# 1992 Corvette: Service Bulletin: Hood Latch Striker Bolt

**Subject:** HOOD LATCH STRIKER BOLT (USE PAST MODEL SERVICE PARTS)

**Model and Year:** 1992 Corvettes, Prior to VIN Breakpoint N5100919

**Bulletin Number:** 92-43-10 - (11/07/1991)

VIEW A

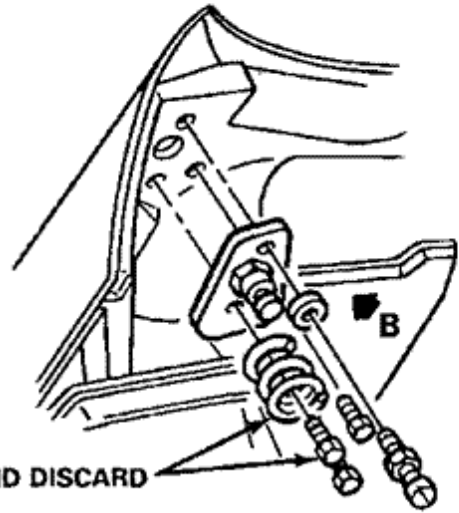
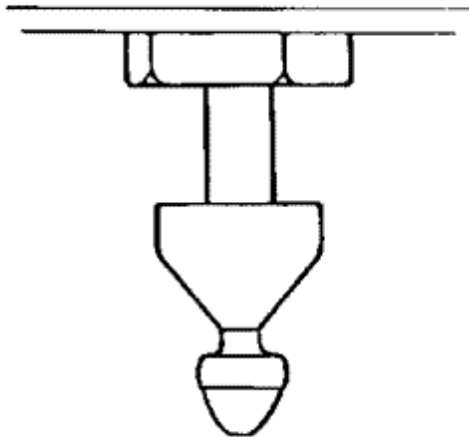
1. Raise hood to full open position. 2. Remove pop up spring and attaching bolt from bracket and discard (see View A). 3. Install new attaching bolt in position, tighten and torque to 27 N.m (20 lbs. ft.). 4. Loosen the locking nut on the striker latch bolt, remove bolt and nut from hood bracket, disassemble nut from bolt and save the nut for use on the new striker bolt. **DISCARD THE ORIGINAL STRIKER BOLT.** 5. Preassemble the new bolt, retainer, spring and original lock nut (see View B).

VIEW B — PRODUCTION

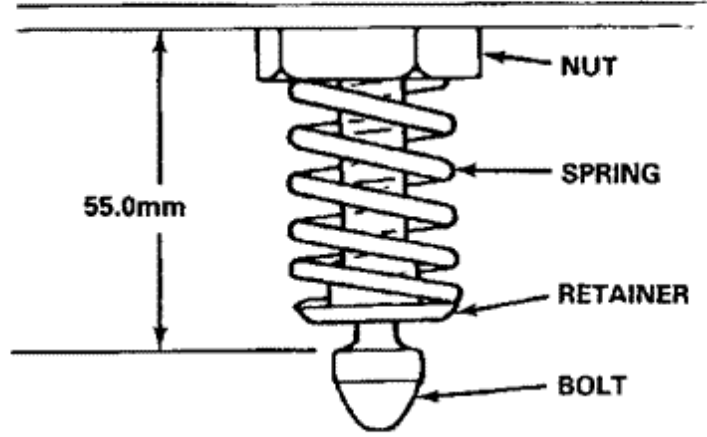
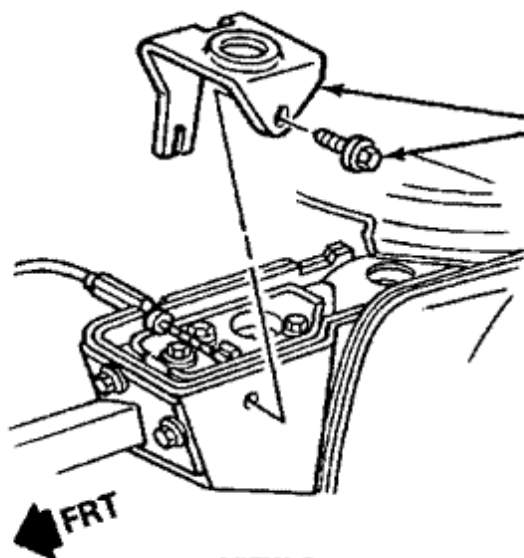
**NOTE:** The nut has a cavity on one side to act as spring seat.

6. Install the new striker bolt assembly to the bracket on hood, set initial

VIEW C  
OUTSIDE VIEW

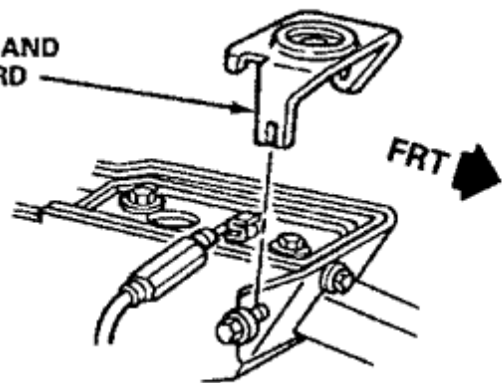
height as indicated on the illustration and tighten the locking nut. 7. Remove the outer attaching bolt for the spring seat (View C), loosen the inner attaching bolt and remove and discard the spring seat and outer attaching bolt. 8. Tighten the inner attaching bolt and torque to 25 N.m (18 lbs. ft.), see View C, inside View. 9. Carefully lower hood, check for latching and flushness conditions and adjust as required.
